Technical Communications Bulletin 17.023

ECRN 2017-0697

This procedure applies to all S1930 and S1930E machine models. The purpose of this bulletin is to inspect the spindle retaining bolt for abnormal wear. If during inspection the bolt has been found to show signs of wear a replacement bolt will need to be ordered from your local Snorkel Parts Department.

S1930

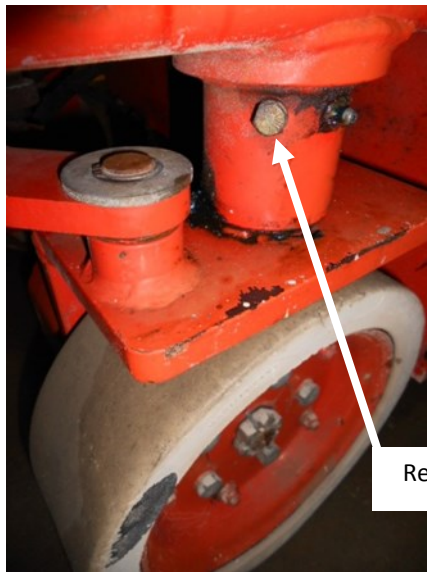
The Snorkel S1930 and S1930E Steering Spindles are each retained in the chassis by a High Tensile bolt, and spring washer. The bolt protrudes into a groove machined onto the Spindle, just far enough to prevent the spindle falling out of the chassis if the machine is lifted by a forklift or crane, but not far enough to make contact with the spindle during normal operation.

During all Quarterly and Annual Routine Inspections, remove and check the retaining bolt on both steer spindles for wear and replace as required - refer to the parts listed above. Replacement bolts will be longer than the original bolts, so a flat washer **must** be used in conjunction with the spring washer. Ensure the spindle rotates freely without binding.

S1930E

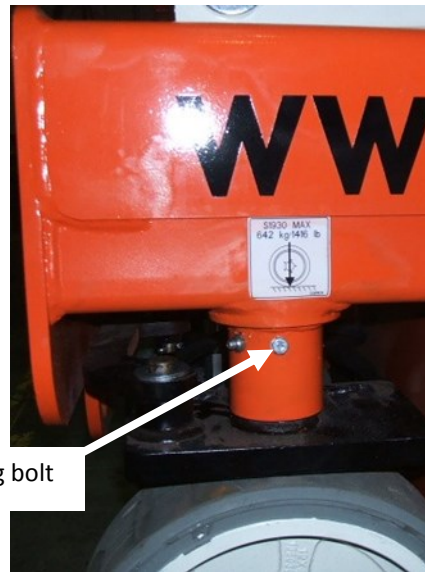
Retaining bolt

In time the end of the bolt may wear, particularly if the machine is lifted and moved frequently by crane or forklift. If the end of the bolt wears excessively the Steer Spindle may not be fully retained in the chassis and may fall out when the machine is lifted.
